SECOND REVIEW
WC³ Project #: 217-525-147

Subject: Miguel McKelvey SFD – Plan Review Comments (2nd Review)

Project Name: Miguel McKelvey SFD

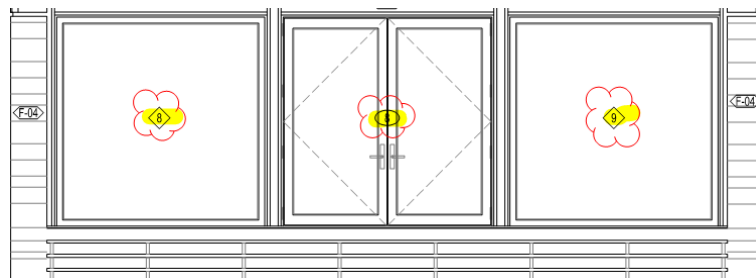
- A. The doors and windows are identified with keyed references. However, a door and window schedule does not appear to be a part of the plans. Ensure all tempered glazing is identified on the schedule.

PC2: Door 8 and Windows 8 and 9 are required to be tempered glazing, per IRC 308.4. Please note this information on the door and window schedules.

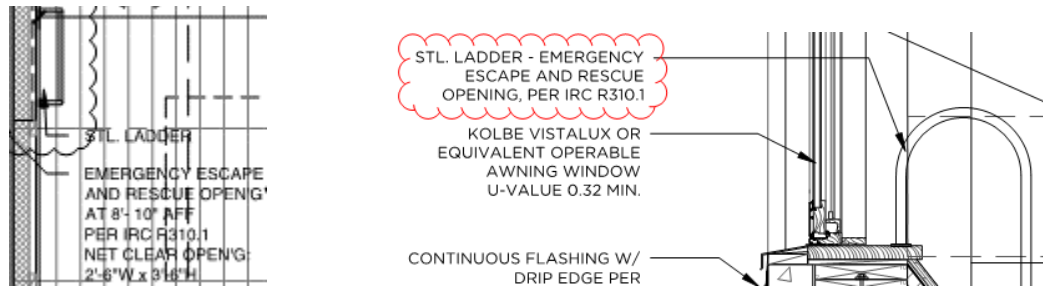
- B. The window in the master bedroom does not meet the requirements for emergency escape and egress openings, as required by IRC R310.1.

PC2: The emergency escape and rescue opening in the master bedroom is identified with a sill height on 8'10". Per IRC R310.2.2, the sill height shall not be more than 44 inches above the

floor. This sheet and Detail 5/A-504 identify a steel ladder for emergency escape and references R310.1. IRC R310.1 does not identify or allow such a ladder for emergency escape and rescue. Make all necessary corrections to the plans to provide a code compliant emergency escape and rescue opening in the bedroom.

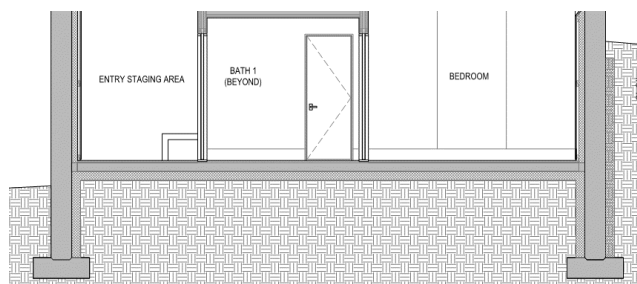
PC2: The REScheck identifies four basement walls as solid concrete below grade with R-46 continuous insulation.

1) ***There are no concrete walls below the concrete slab.***

2) ***A substantial portion of the structure is above grade.***

3) ***At the location of the below grade concrete wall, detail how R-46 continuous insulation will be achieved. Normally, a concrete wall will be furred and cavity insulation installed in the furred space.***
